Product Change Notification

MULTIFUSE® PPTC RESETTABLE FUSES

Bourns® Radial Leaded Multifuse® Polymer PTC Resettable Fuses

Changes to Tape and Reel Packaging

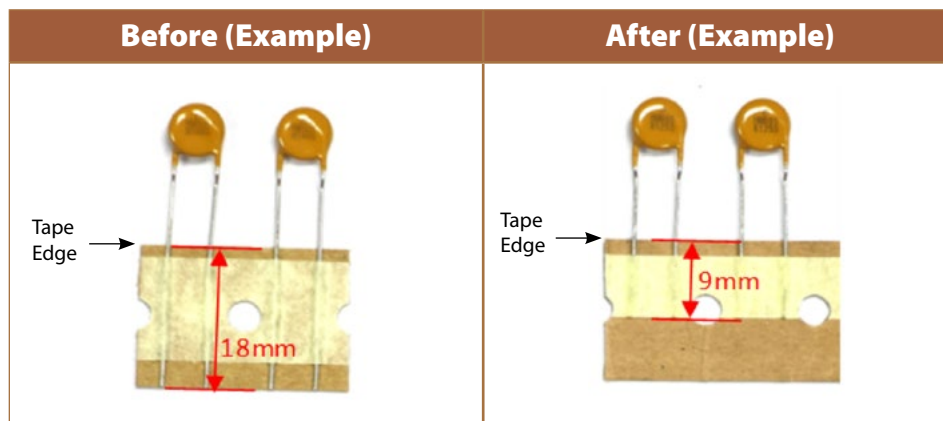
Lead Length Scrap Reduction

For the Multifuse® models listed in the “Affected Part Numbers” table in this PCN, the total length of the leads will be shortened as shown in the example pictures below. The actual dimension changes will vary between models. However, assuming the components are removed from the tape and reel packaging by cutting the leads at the tape edge, the form, fit and function of the components are not affected. Only the length of the scrap lead material remaining in the tape will change. There is no change in the mechanical, electrical or material properties, and the components’ performance and agency recognition remains the same. Changed products can be identified by date code according to the implementation timeline outlined in this PCN. Samples are available upon request.
